HATFIELD BOROUGH PLANNING COMMISSION

3. 23 N. Main Street Arbor Grove Development Sketch Plan Presentation

RE: 23 N. Main Street Sketch Plan Review
Bursich Project No.: HAT-01/228286

Re: Sketch Plan Review of 23 North Main Street

Turning Performance Analysis

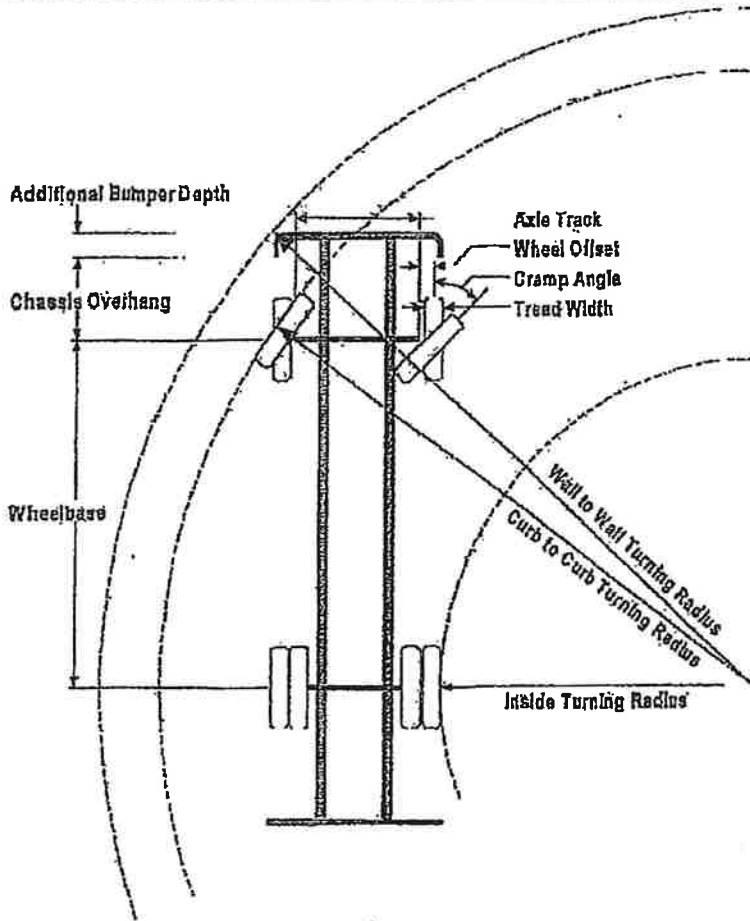
1. Due to the length of the proposed dead end fire lane a fire apparatus access road turnaround must be provided.
 - a. For approval a fire apparatus turning model shall be provided using the attached specifications for the Hatfield Fire Company Ladder Truck. The turning radius of the street and the apparatus turnaround shall be designed to accommodate the requirements for this apparatus.
 - b. The purpose of this model is to confirm that the fire apparatus will be able to enter and exit the property including the using the provided fire apparatus access road without leaving the paved surface with minimal backing of apparatus.
